AE 4100 Front panel PCB inner side
Modification for 40/40 Channels

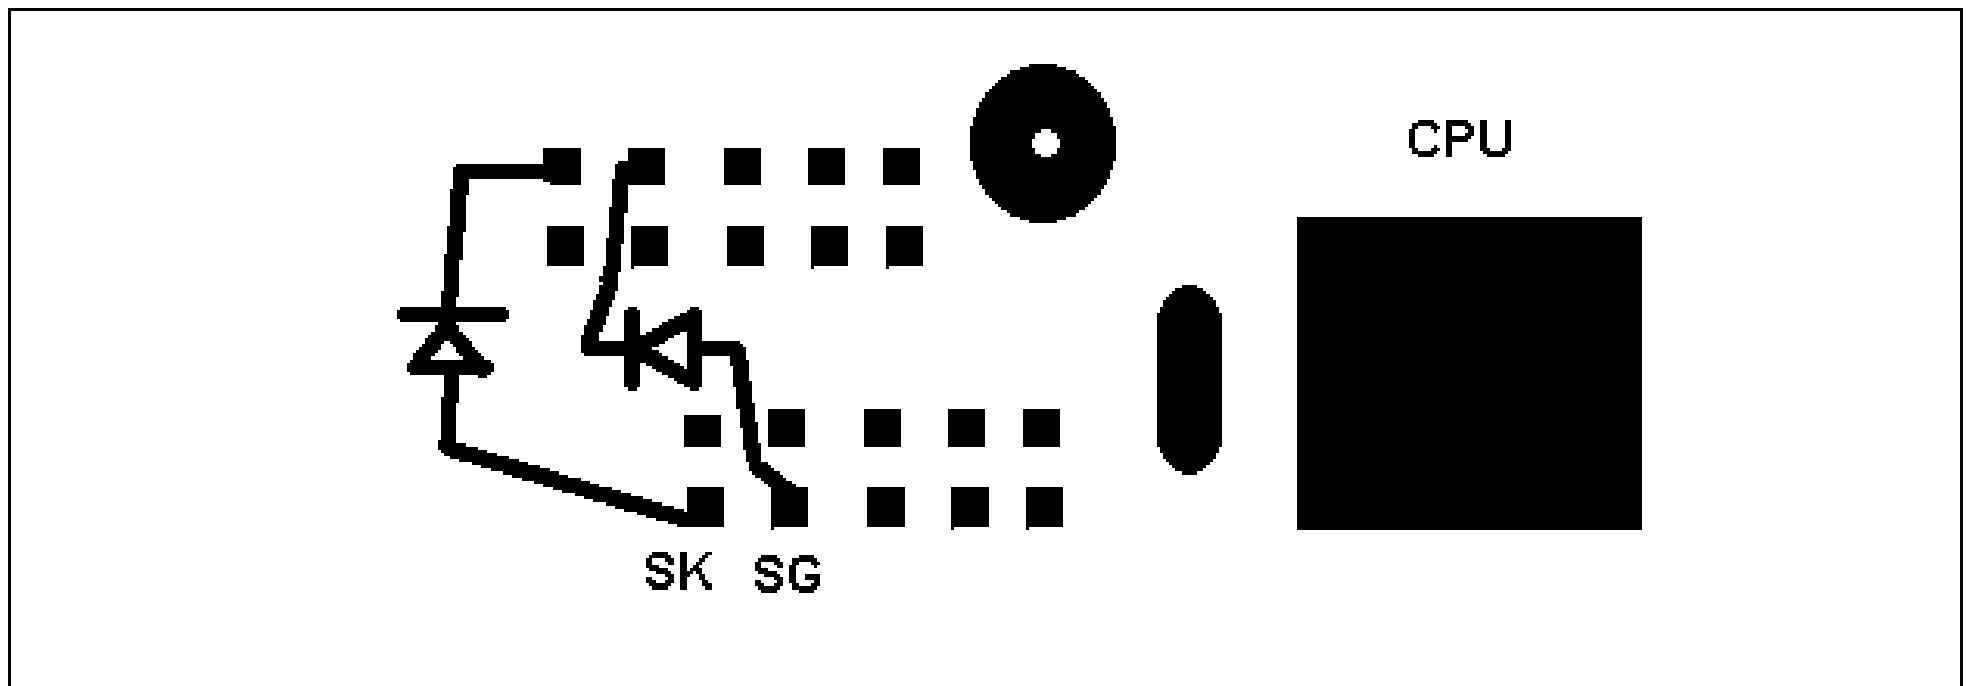
Trimmer Crystal

Additional Diodes (2 x 1 N 4148) for 40 CH AM+FM
